Great Design Fast Track Advice Report

Proposal: PPA-1135– ‘Hanover Street’, 8-storey apartment development
Address 64-70 Hanover Street, Fitzroy
To The Hon. Sonya Kilkenny MP, Minister for Planning
From OVGA
Date 04 February 2026

Artists' impression, view from Hanover Street

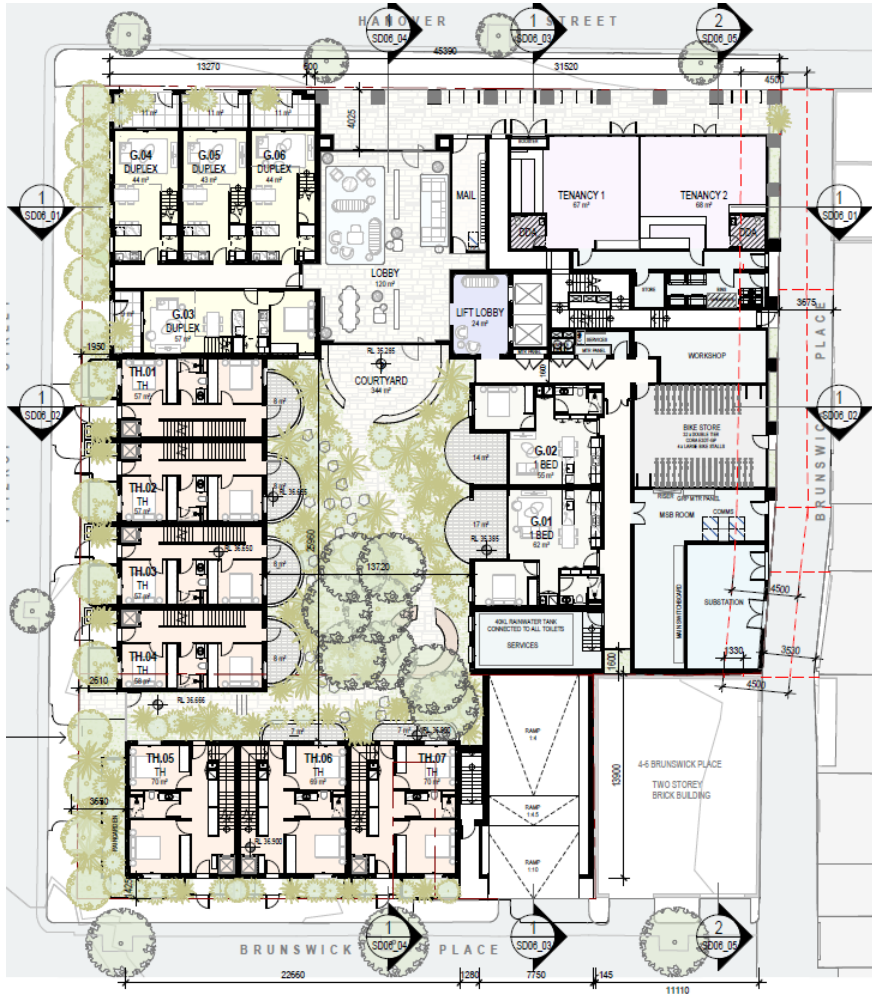
Recommendation: It is critical that the quality, ambition and detailing shown in the renders is delivered through construction and is not reduced.
